Re: Docket No. 20250121-GU – Joint petition for approval of actual, estimated, and projected relocation costs and approval to establish a recovery surcharge, by Florida City Gas and Florida Public Utilities Company.

Responses of Florida City Gas and Florida Public Utilities Company to Staff's First Data Request

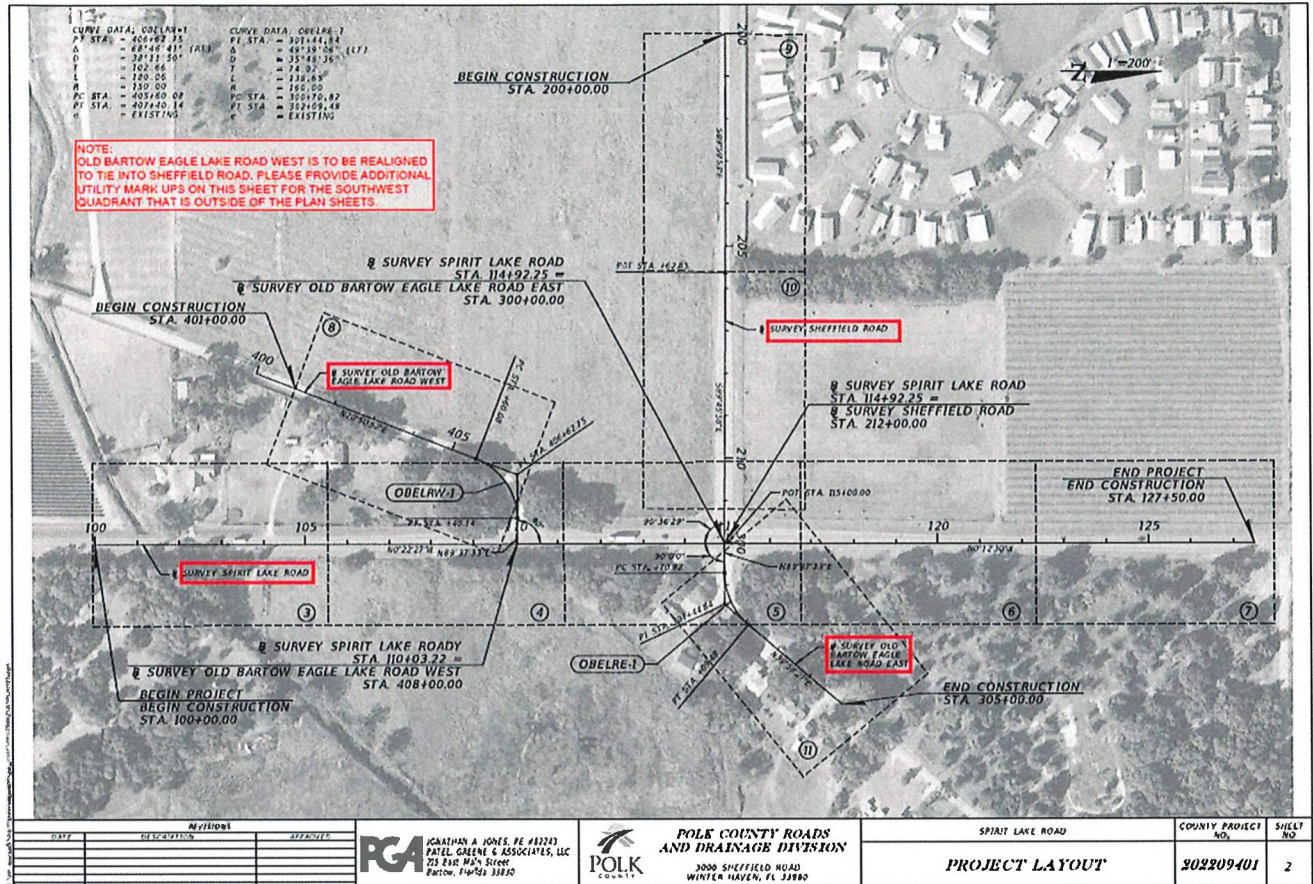
13. Please refer to witness McCloskey's pre-filed Exhibits SM-1 FPU, page 1, and SM-2 FPU, pages 51 through 56. Verify the project location and the name of the requesting authority.

As shown in the title on page 51 of SM-2 FPU, Polk County is the requesting authority whose project limits can be seen in the image below. FPUC's impacted facilities are at the intersection of Old Bartow Eagle Lake Rd. East, Sheffield Rd, and Spirit Lake Road.
